APPEAL SUMMARY

Appeal ID: 26334	Project Address: 7206 SE 36th Ave
Hearing Date: 12/8/21	Appellant Name: Jeffrey T Parrish
Case No.: B-007	Appellant Phone: 5036797558
Appeal Type: Building	Plans Examiner/Inspector: David Hakimoglu
Project Type: residential	Stories: 1 Occupancy: R-5 Residential Construction Type: Wood Frame
Building/Business Name:	Fire Sprinklers: No
Appeal Involves: Alteration of an existing structure, occ Change from T to	LUR or Permit Application No.: 20-227000-RS
Plan Submitted Option: pdf [File 1] [File 2]	Proposed use: Basement ADU

Code Modification or Alternate Requested Install 32"W by 76"H basement ADU egress door

PROPOSED STAIR SECTION

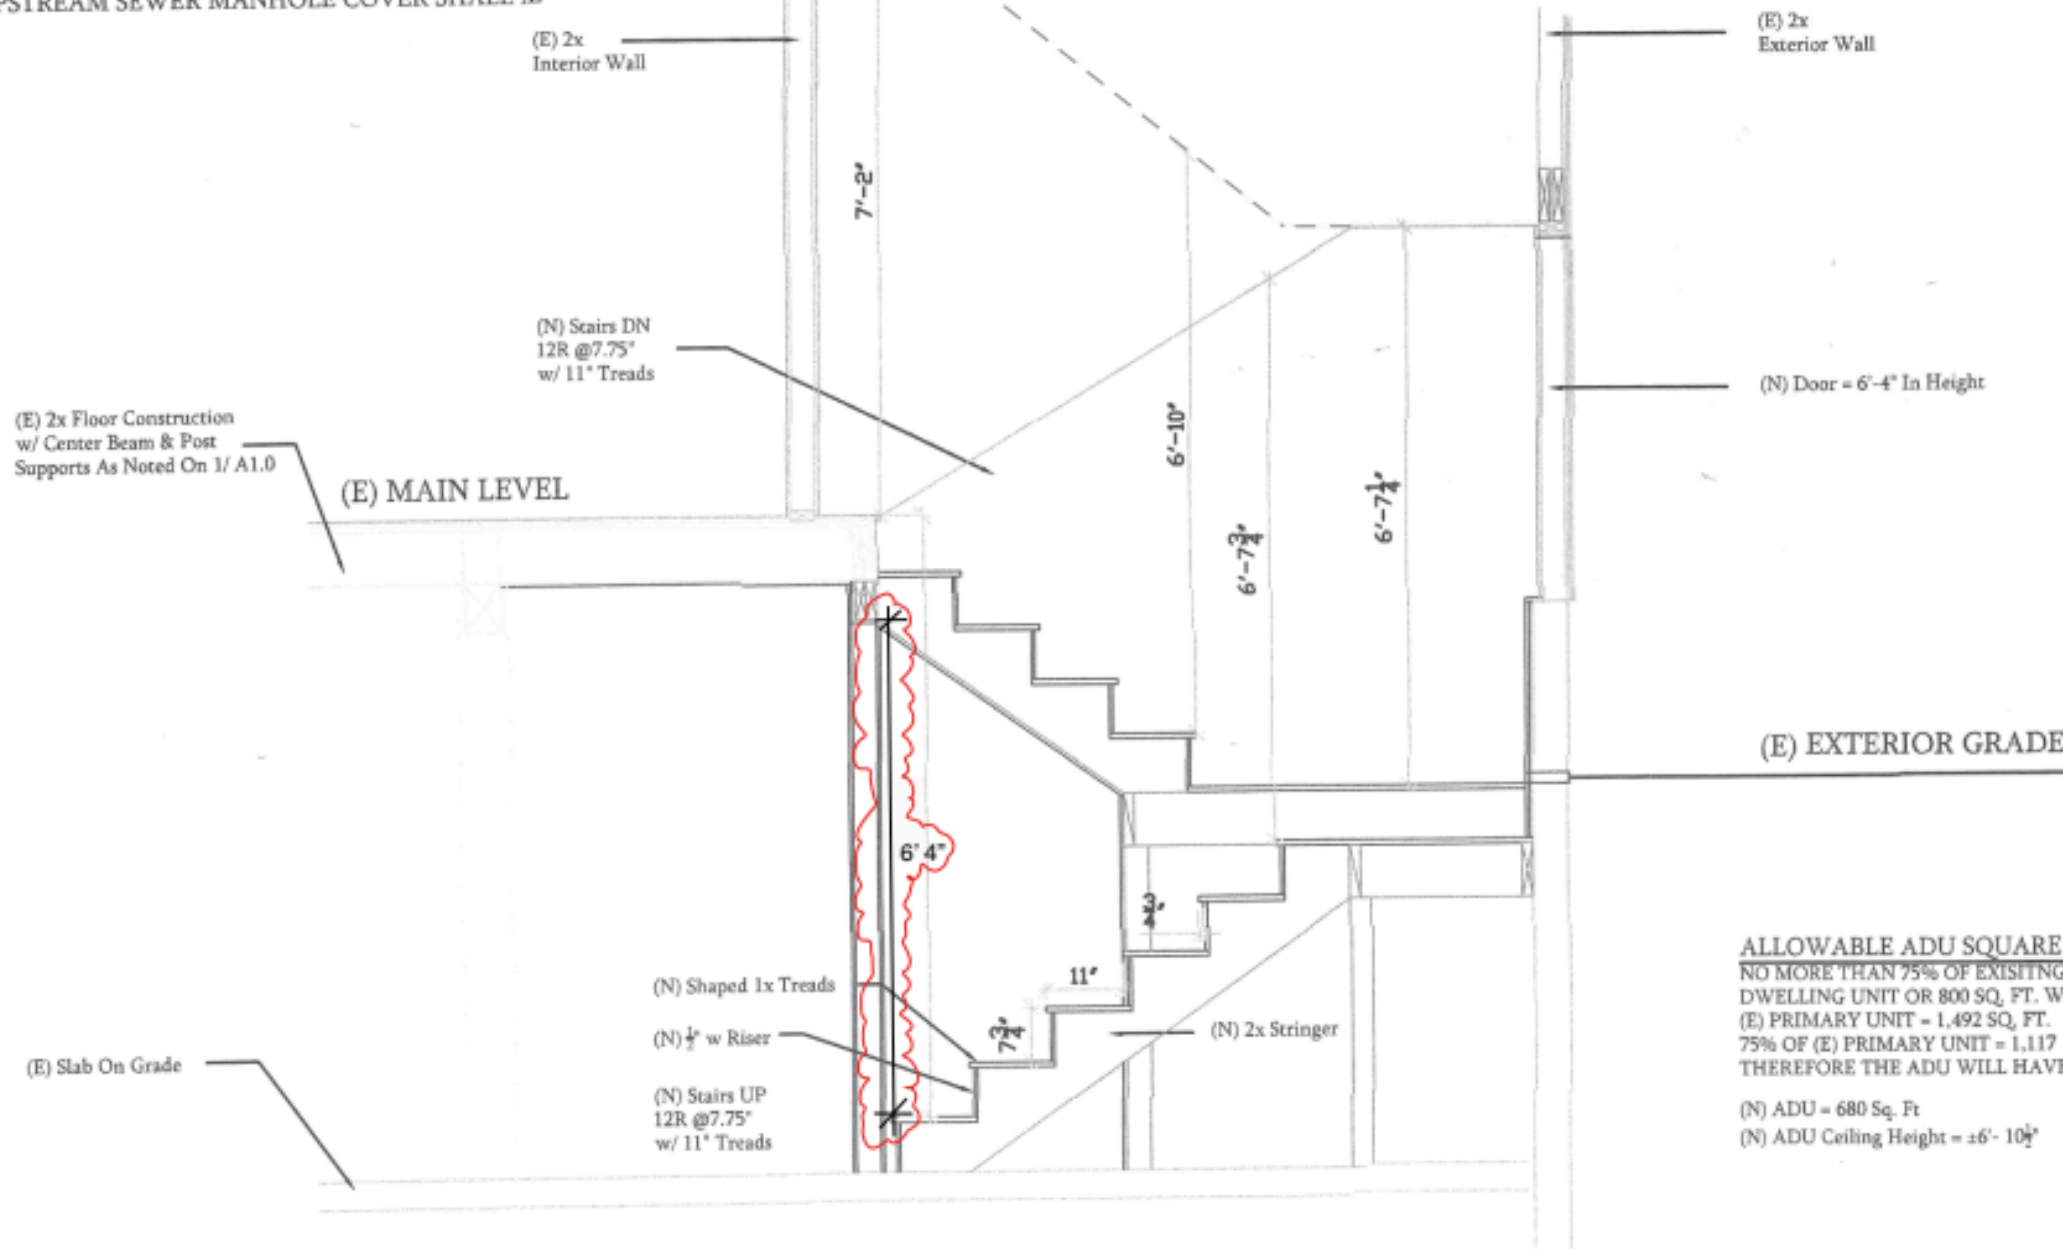
Proposed Design Modify width and maximize height of existing opening to accommodate 32"x76" basement ADU egress door, as shown on original, approved plans.
Affix signage to warn of lower head height.

Reason for alternative Due to existing stair landing above existing door, maximum height only allows for 76" height door. Extremely extensive, cost-prohibitive modifications to roof and upper stairwell and/or exterior concrete walk way, foundation and sewer line prohibit a taller door.
Though an ADU, door will be within parameters of City of Portland exterior basement egress door for converted basements requirements.
Caution signage on both sides of door will warn of potential overhead clearance issues.

***Please note: Stairwell heights shown in provided approved plans section have been brought into compliance of 6'8" minimum height.

Basement ADU with reduction in the minimum required height of entry doors from 6 feet 8 inches to 6 feet 4 inches: Denied. Proposal does not provide equivalent Life Safety protection.
Appellant may contact Dave Tebeau (503-823-4072) with questions.
